Entergy Nuclear Operations, Inc.
Pilgrim Nuclear Power Station
600 Rocky Hill Road
Plymouth, MA 02360

SUBJECT: Pilgrim Nuclear Power Station
Docket No. 50-293
License No. DPR-35

Proposed License Amendment: Revision to the Technical Specification (TS)
Surveillance Requirement (SR) Frequency for Containment and Suppression
Pool (Torus) Spray Headers and Nozzles Inspections (TS 4.5.B.2.2)

LETTER NUMBER: 2.04.033

FIGURE
UPPER AND LOWER SPRAY HEADER ASSEMBLY LOCATION PLAN VIEW
(EL. 33'6" AND EL. 54'6")

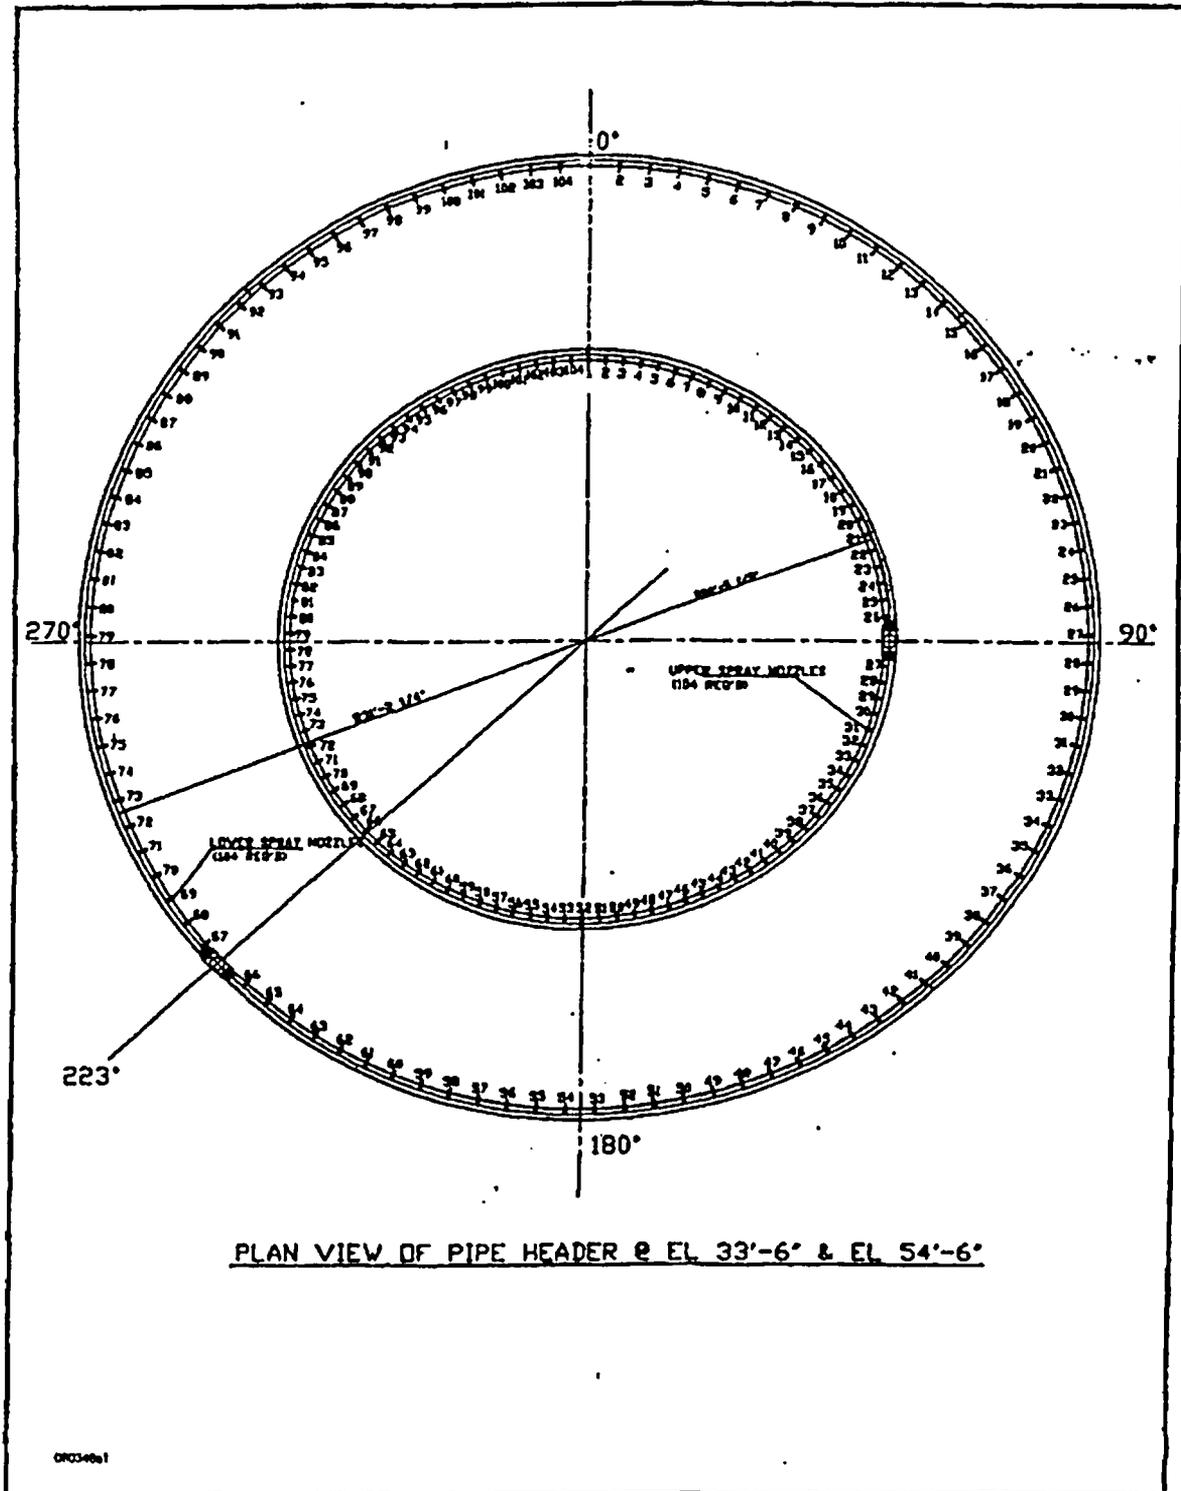
The Pilgrim containment and suppression pool (torus) spray systems are part of Residual Heat Removal (RHR) system and consists of two drywell spray loops and one torus spray loop. The drywell spray loops consists of an upper spray header, sparger A and a lower spray header, sparger B. The lower sparger has 196 spray nozzles and the upper sparger has 208 spray nozzles mounted symmetrically (see Upper and Lower Spray Header Assembly Figure). The torus spray loop consists of 6-spray nozzles within the torus space.
